AMEREN/UE
DOCUMENT CONTROL SYSTEM
DOCUMENT TRANSMITTAL

TEMPORARY CHANGE NOTICE REQUEST FORM

TCN NO. 00-400

1. **PROCEDURE NUMBER** EIP-ZZ-C0010 **REVISION NO.** 021
PROCEDURE TITLE EMERGENCY OPERATIONS FACILITY OPERATIONS

BEOF LAYOUT

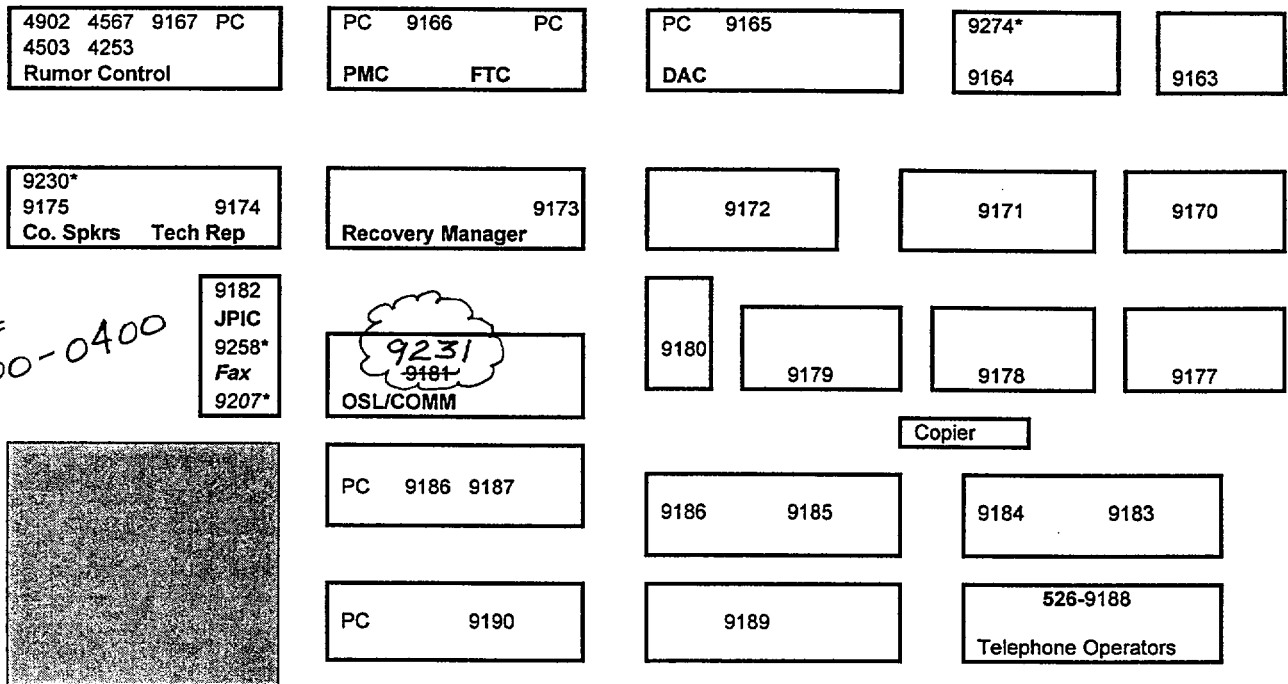
This change is to correct the Off Site Liaison Coordinator's phone number in the Backup EOF (SEMA Emergency Operations Center).
